Addendum No. 6

PROJECT NO. 161026-00

PROJECT TITLE: Renovate Plant Science Building - Phase 2

DATE: **November 19, 2026**

1 DEMOLITION PLAN

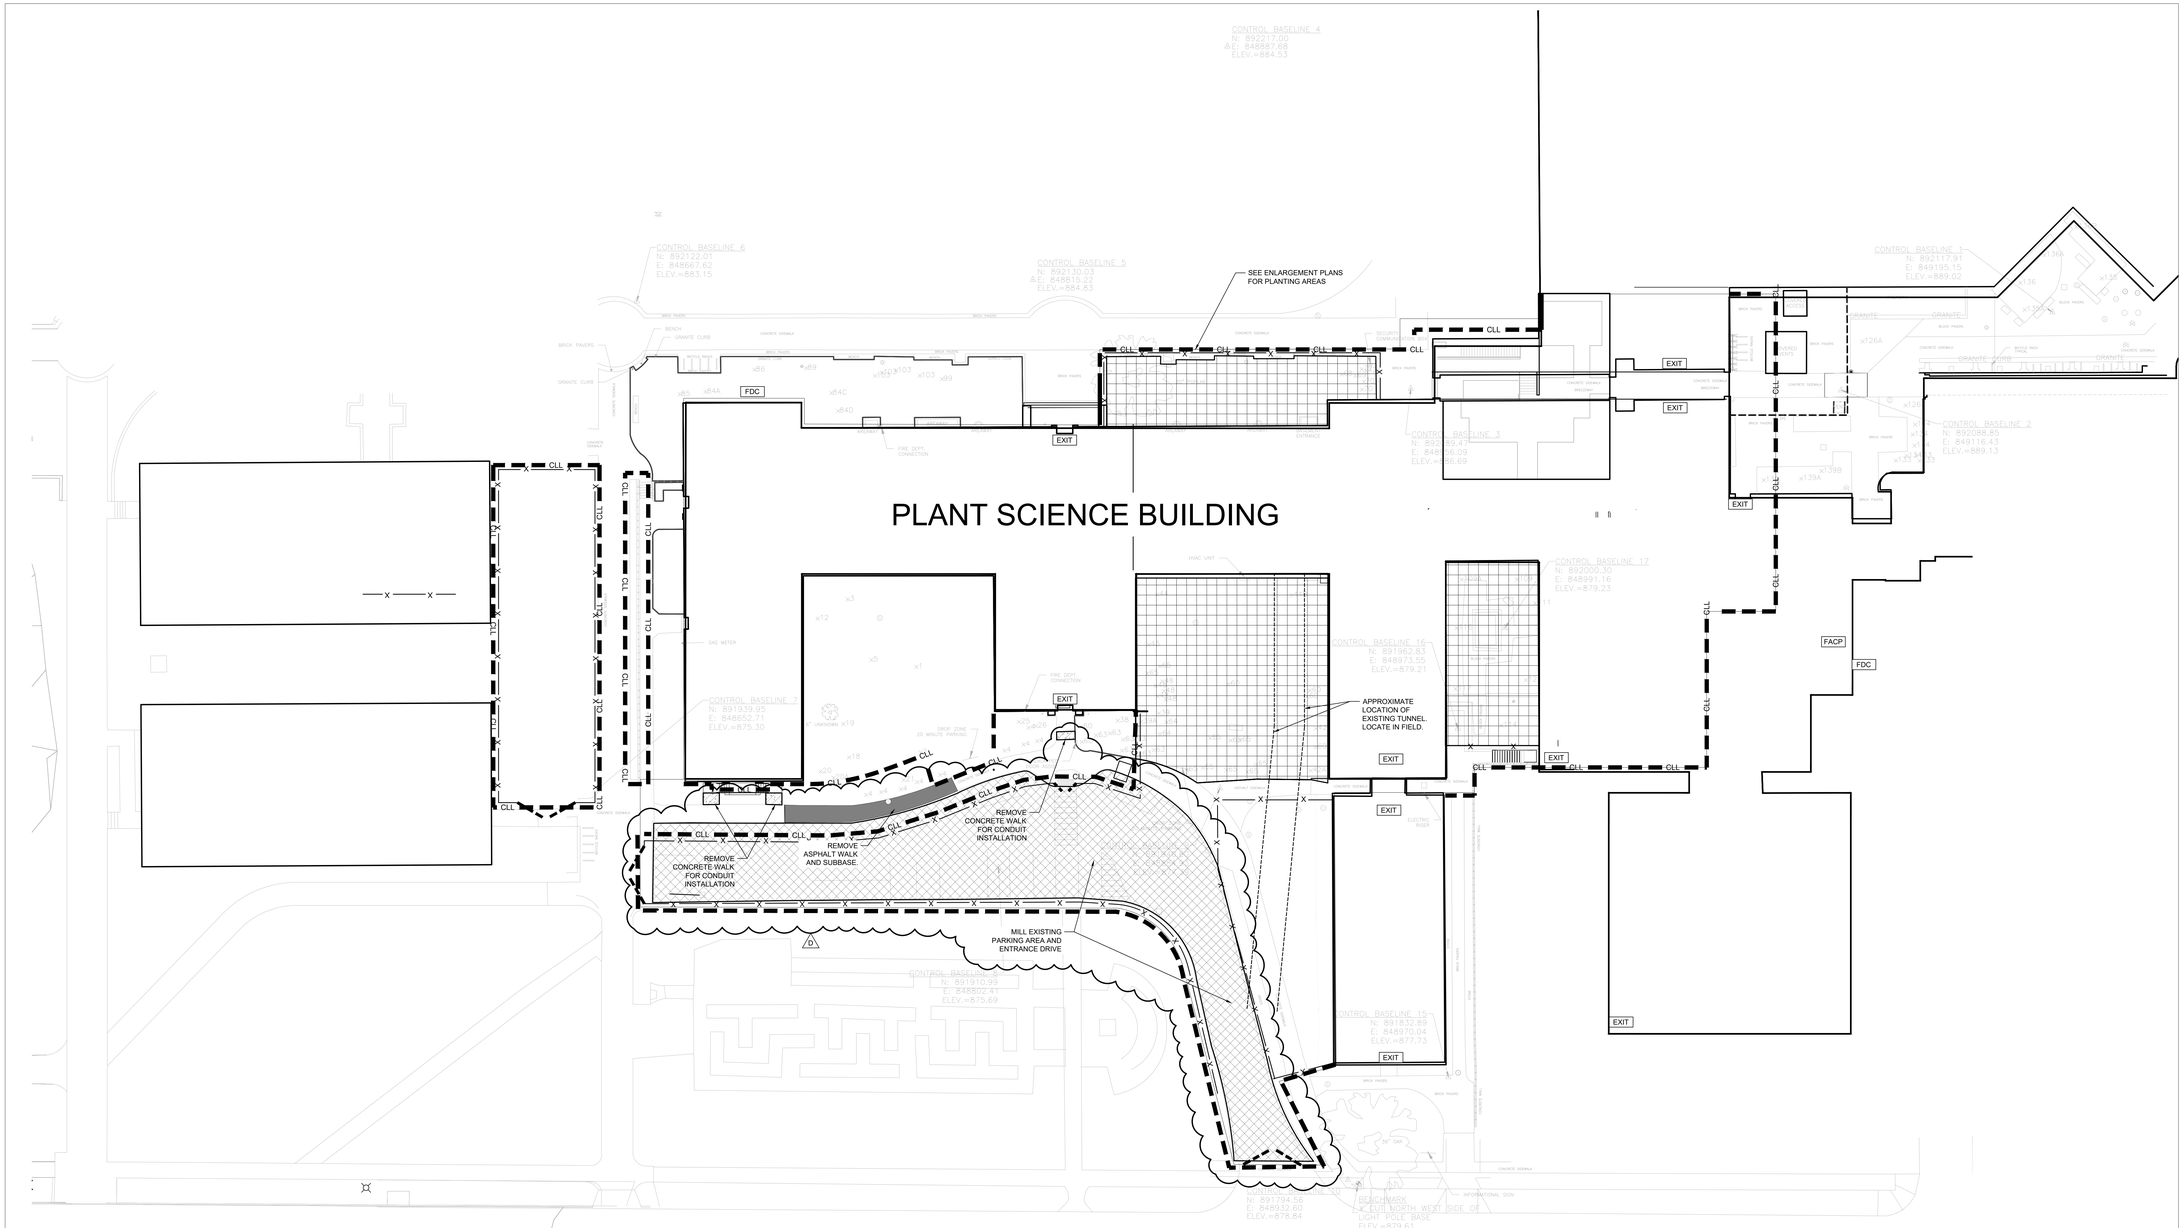
6.2b2: C0.2 – ADDED asphalt walk removal.
6.2c: C0.3 – REVISED text from “REMOVE ARBOR TIES, VINES, AND SEDUM TRAYS FOR SCAFFOLD INSTALLATION” to read: “REMOVE ARBOR TIES, VINES, AND SEDUM TRAYS FOR SCAFFOLD INSTALLATION. TURN OVER SEDUM TRAYS AND PLANTINGS TO UNIVERSITY TO MAINTAIN OFFSITE DURING CONSTRUCTION”.

1 CONSTRUCTION STAGING PLAN

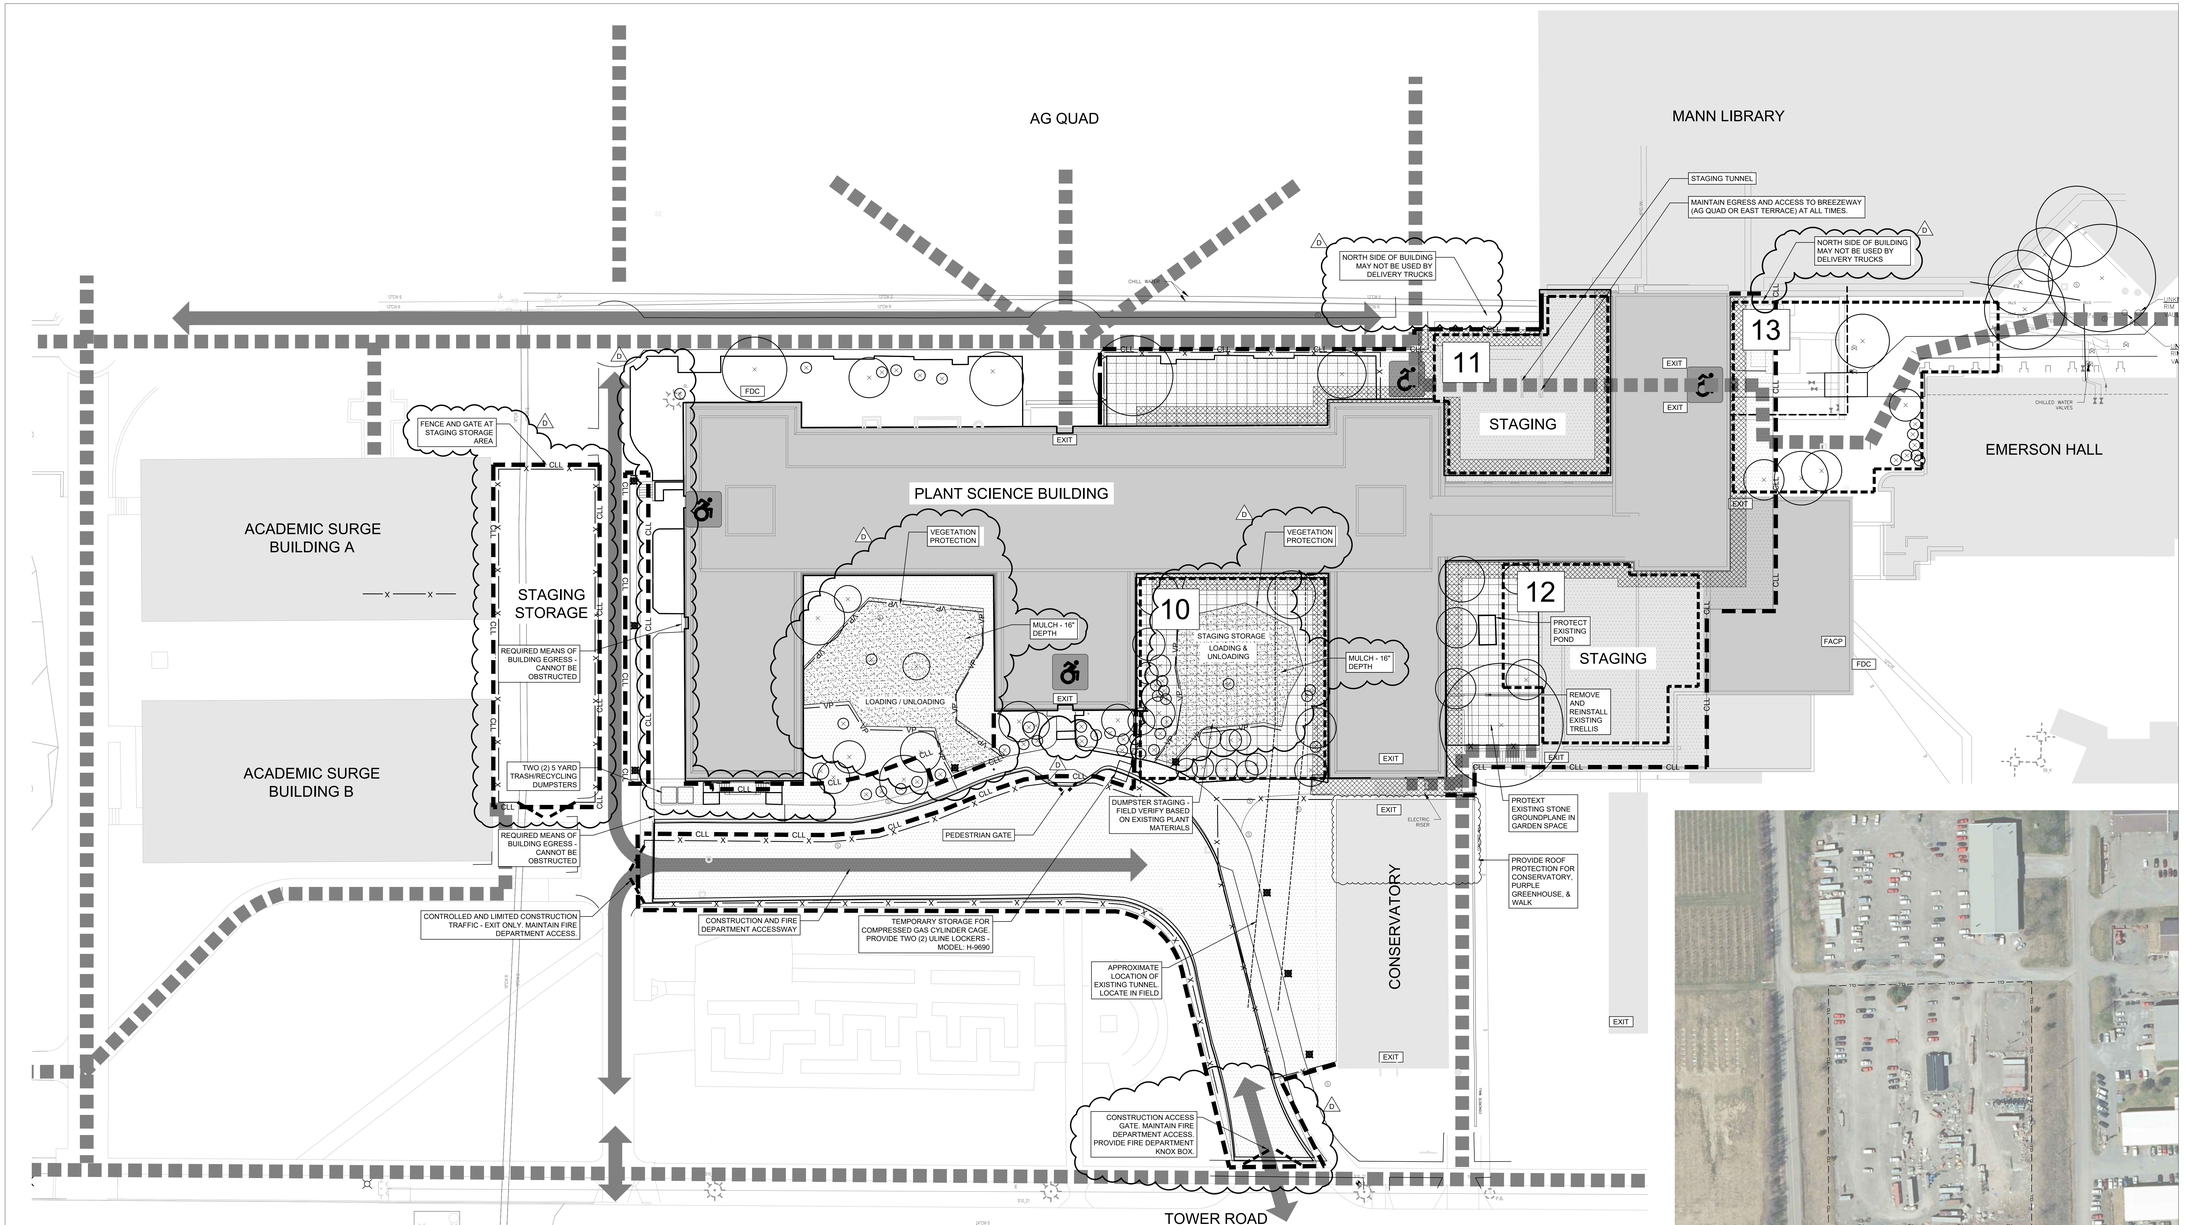
6.2d: C1.1 – DELETED fencing and label at Existing Phase 1 Contractor Trailers. ADDED label “NORTH SIDE OF BUILDING MAY NOT BE USED BY DELIVERY TRUCKS”. REVISED vegetation protection in East and West Courtyards. ADDED fence and gate at staging storage area to west of building.

1 LAYOUT & MATERIALS PLAN

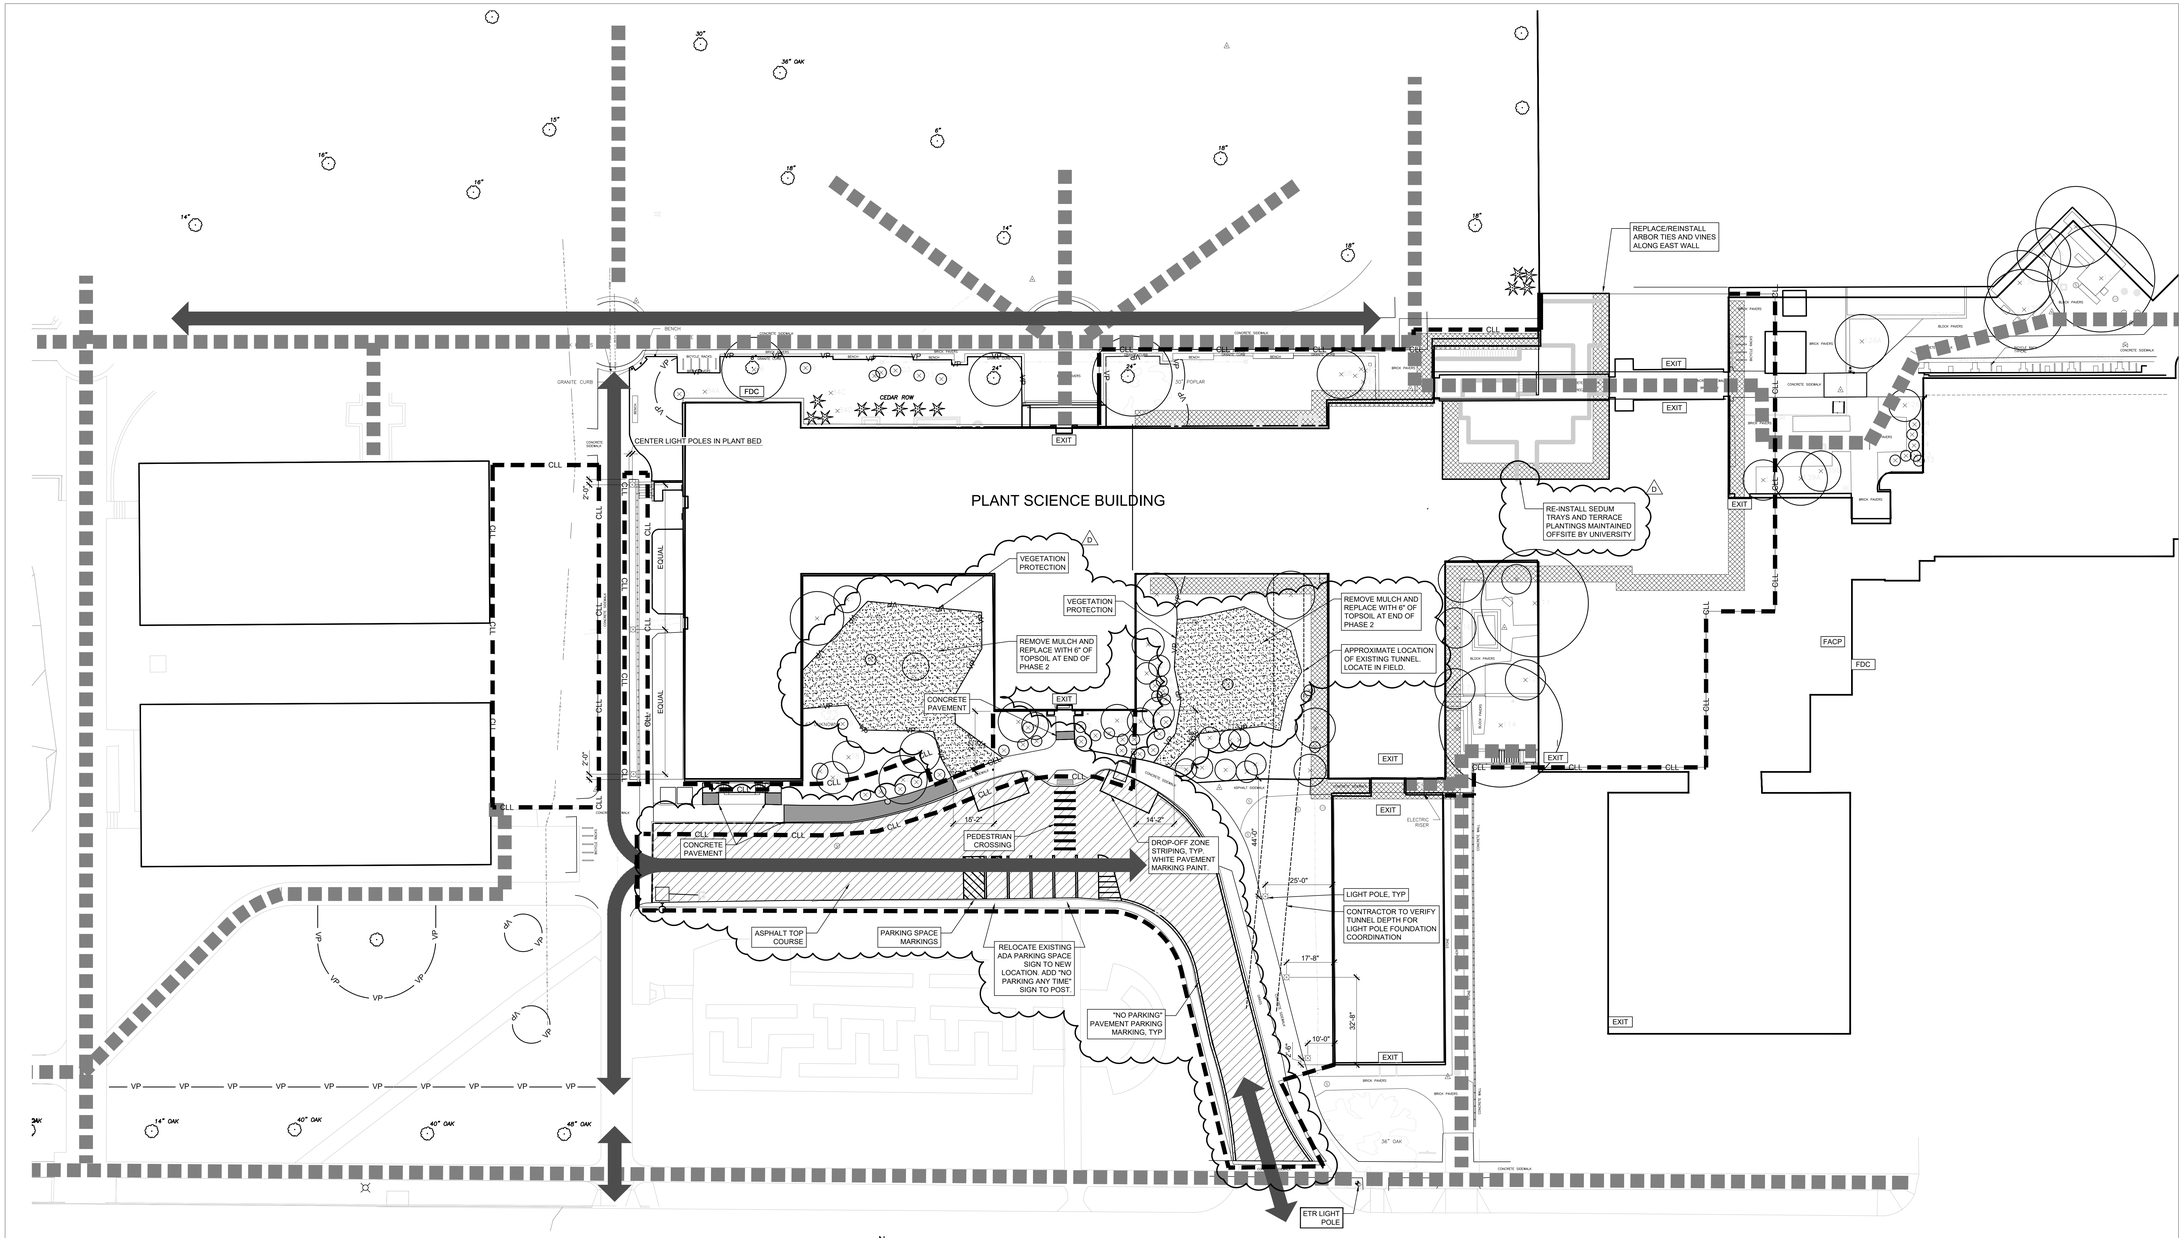
6.2e: C2.1 – REMOVED mulch area at west of building. REVISED Vegetation Protection at West and East Courtyards. REVISED text from “REPLACE SEDUM TRAYS” to read: “RE-INSTALL SEDUM TRAYS AND TERRACE PLANTINGS MAINTAINED OFFSITE BY UNIVERSITY”. REVISED Vegetation Protection and Mulch areas in East and West Courtyards. ADDED section of concrete walk at south of West Courtyard. REVISED Layout and Materials Plan Notes.

1 S1.2 **SECOND FLOOR PLAN - PHASE 2**
1/8" = 1'-0"

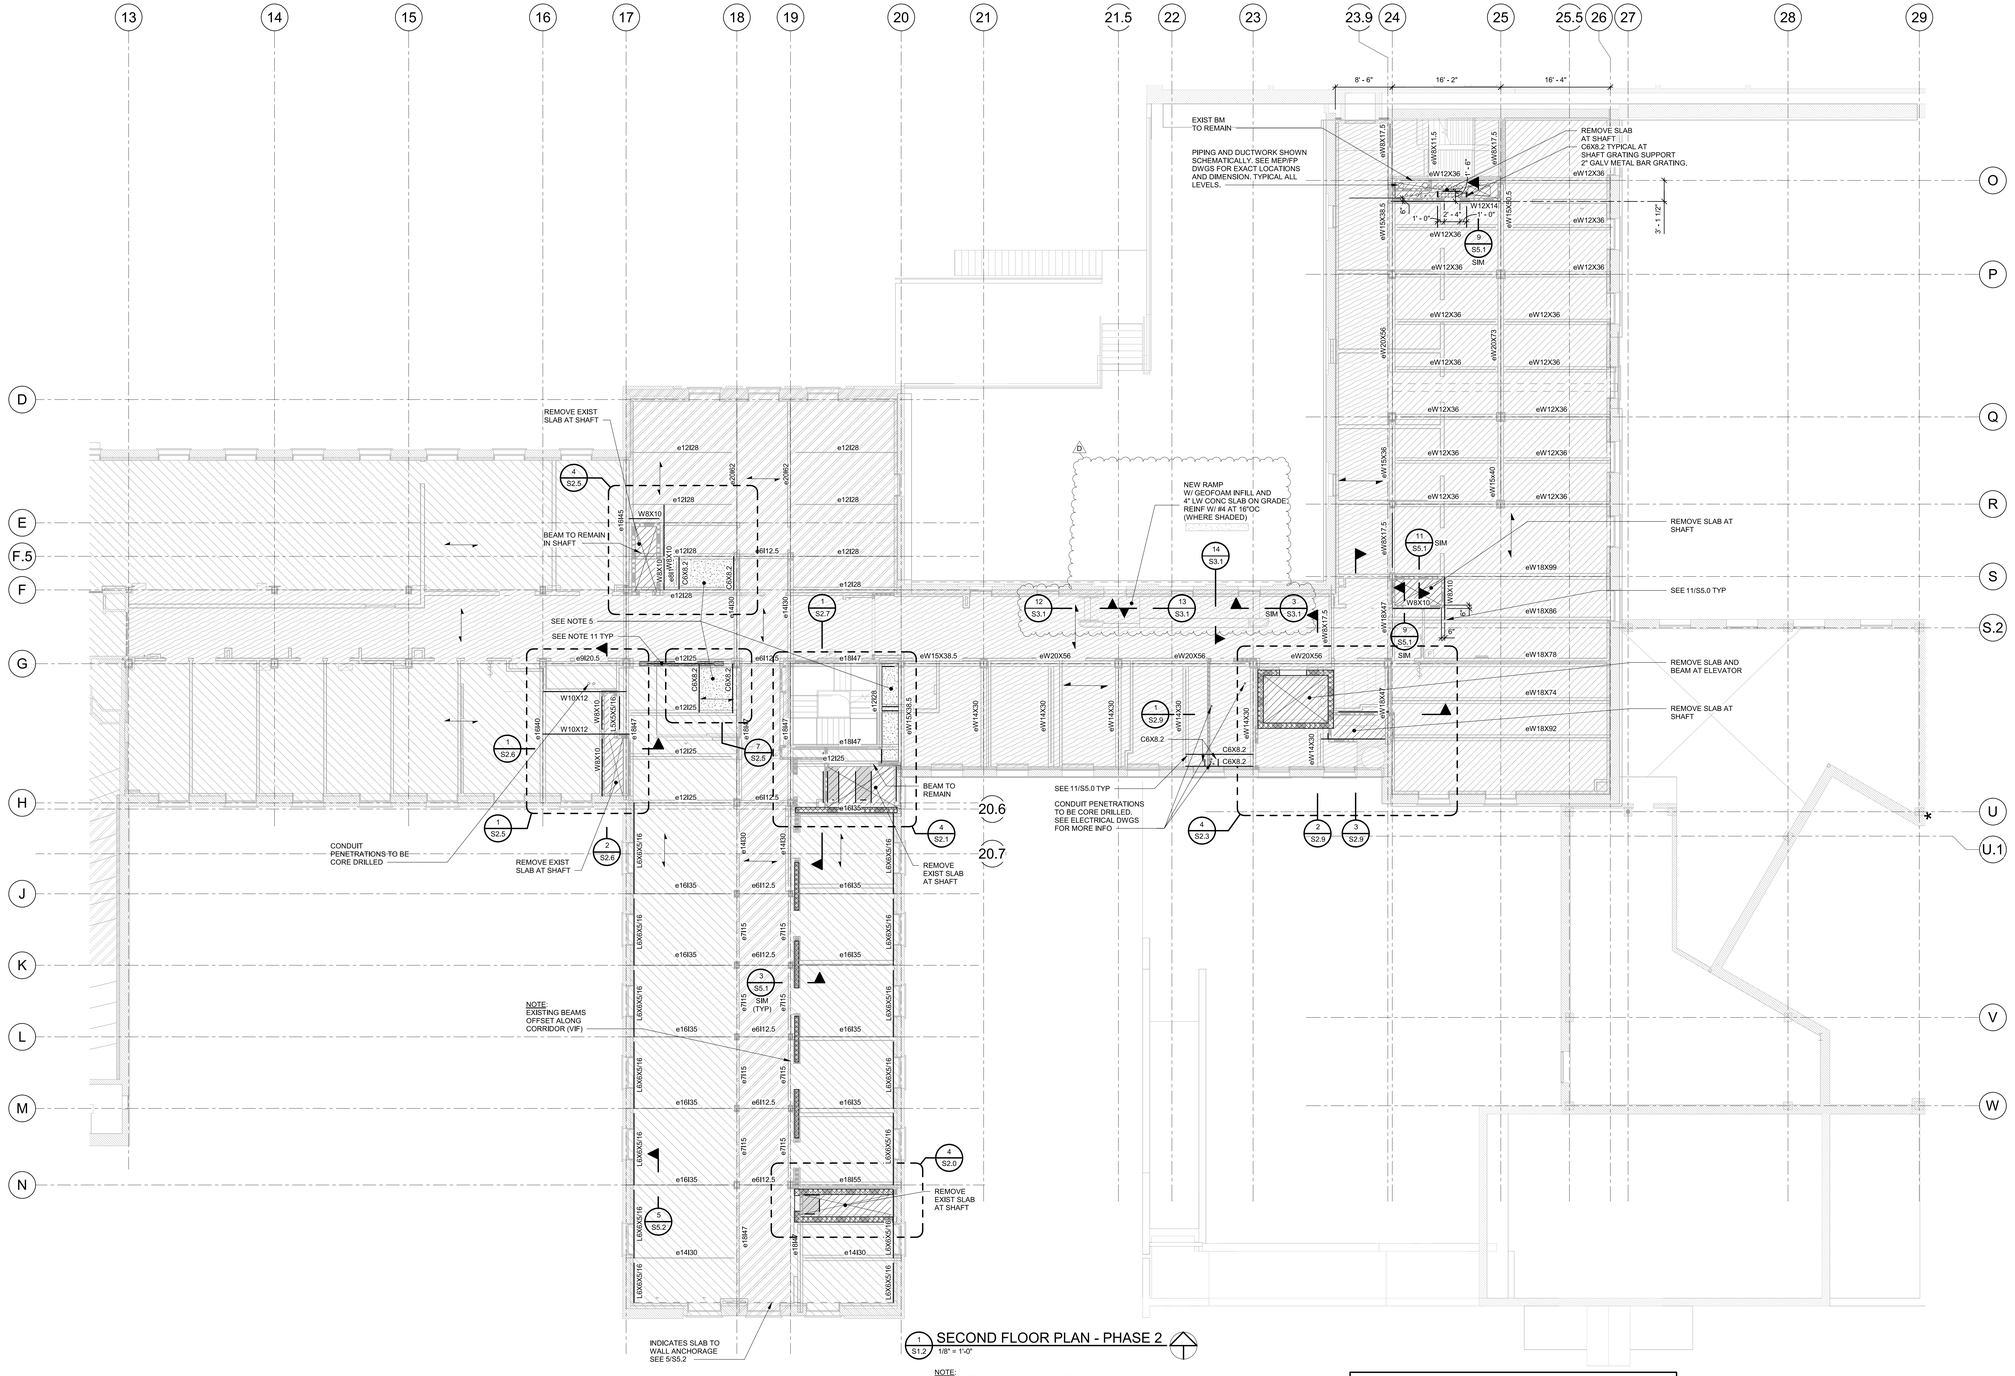
6.2h: HM1.0 – REVISED to incorporate abatement scope at existing to remain piping.
6.2i: S1.2 – REVISED to provide detail references at 2nd floor terrace ramp, stair, and landing.
